Subject: **Request for Modification to the Section 404 Individual Permit and Section 401 Water Quality Certification and Application for Jordan Lake Riparian Buffer Certification** for the proposed Greensboro Eastern Loop from US 70 Relocation to SR 2303 (Lawndale Drive), Guilford County, Division 7. WBS Element No. 34821.1.1, TIP Nos. U-2525B and U-2525C.

**Subject:** Minutes of the Interagency Hydraulic Design Review (4b) Meeting on November 12, 2015 for U-2525C, Guilford County

**Subject:** Final Minutes of the Interagency Permit Drawings Review (4C)  
Meeting on October 19, 2016 for U-2525C in Guilford County

TIP PROJECT: U-2525C

Site 2 was shown in the preliminary drawings for U2525C and overlaps in the mechanized clearing of Site 21 under U2525B. The impacts under U2525B are grayscale on Wetland and Surface Water Impacts Permit Drawing Sheets 6 through 9.

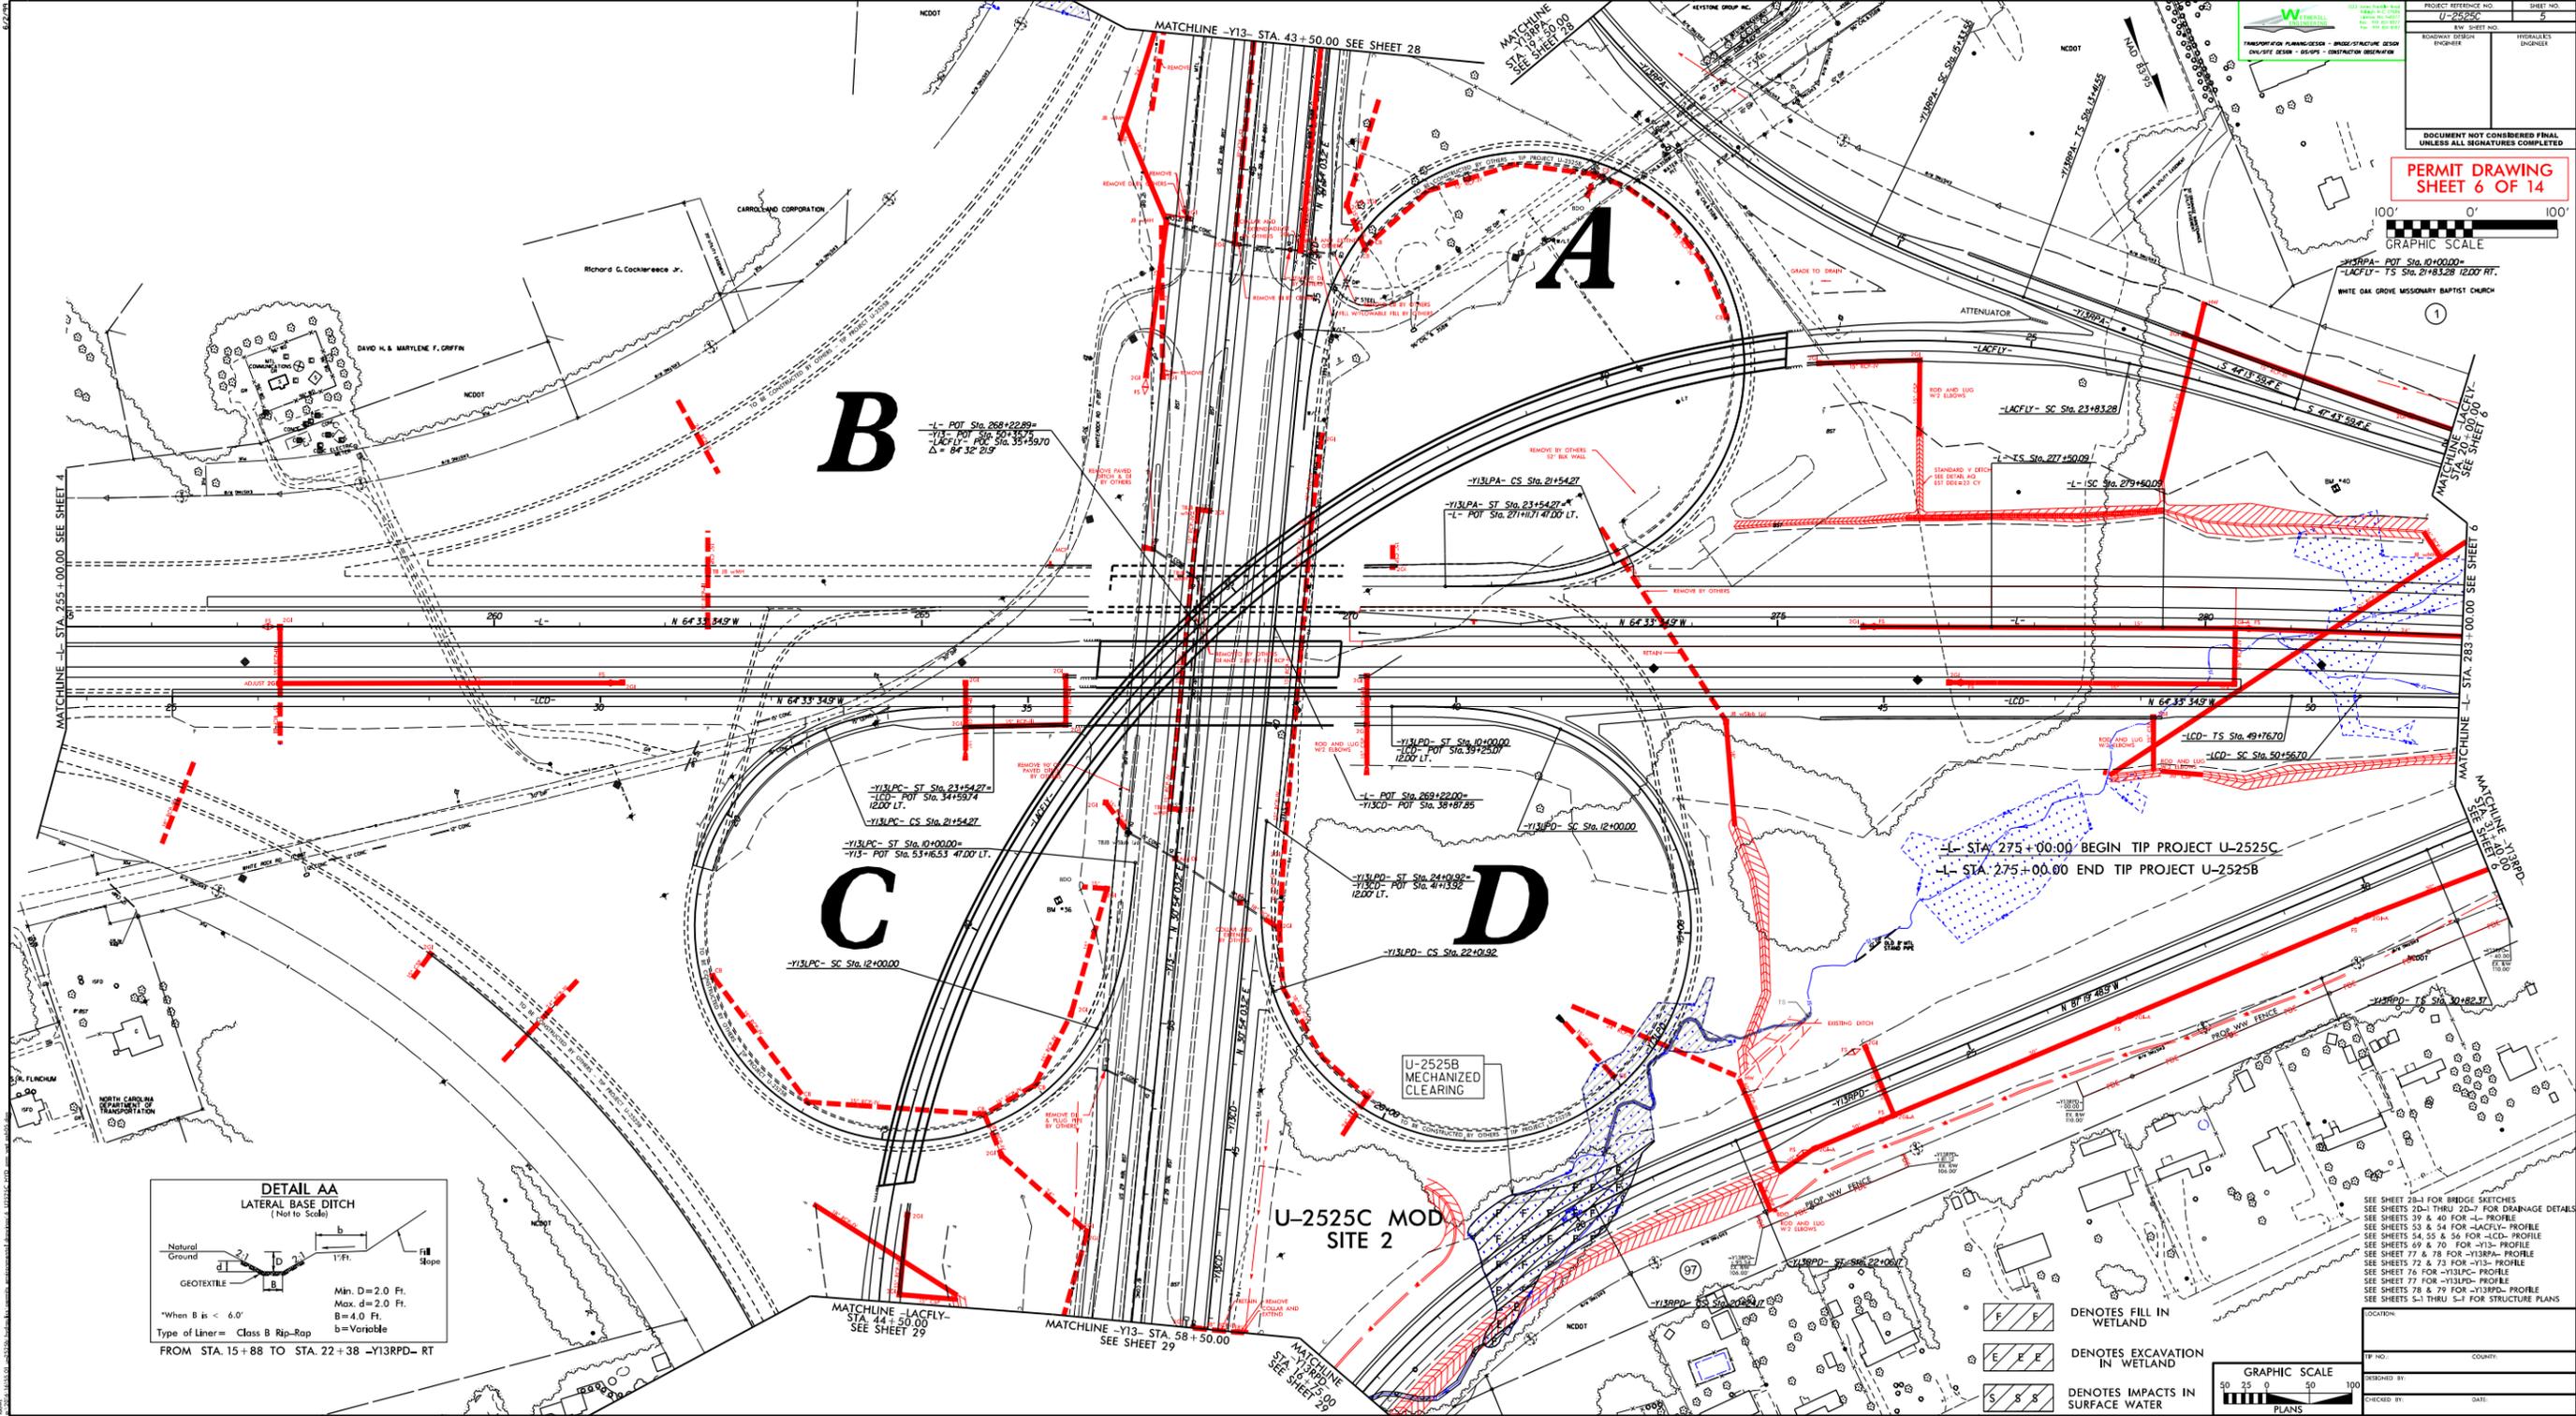
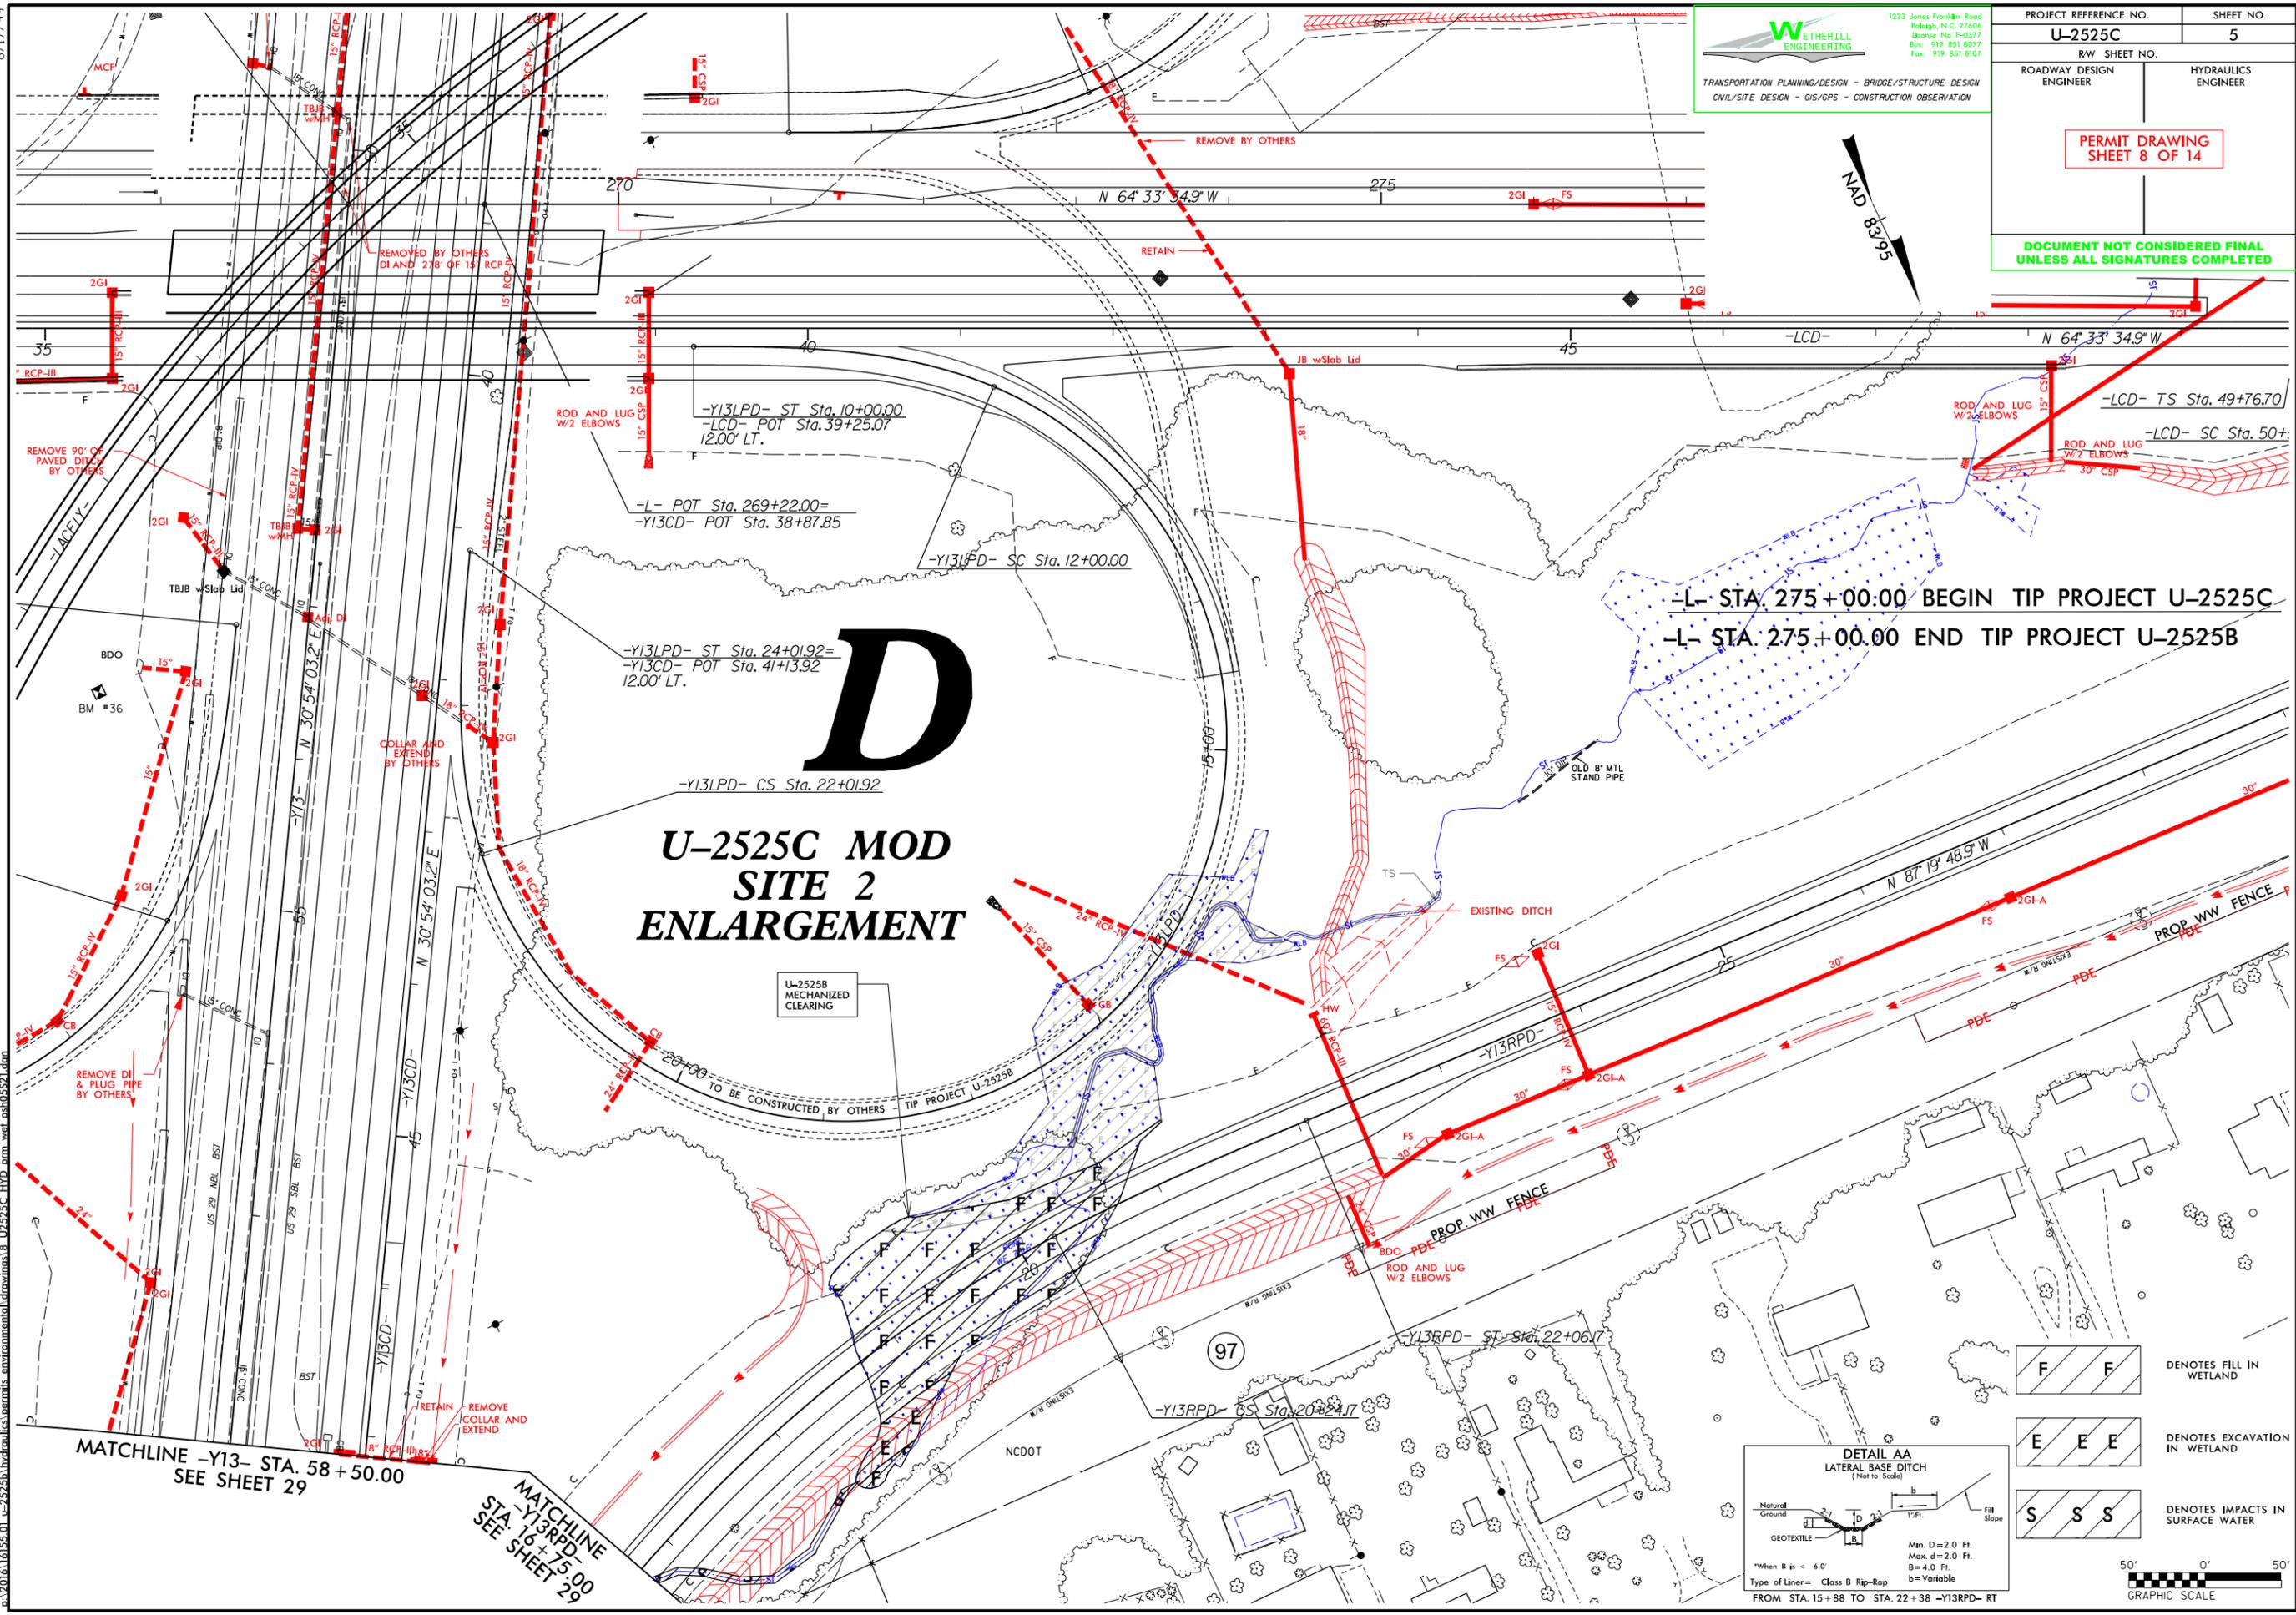
Notice that the wetland that is within the gore area left of station –Y13LPD- 14+50 and left of station –Y13RPD- 26+00 is not proposed to be disturbed. The existing steep topography is not affected by the design. The site can be further discussed with the modification for U-2525C Site 4.
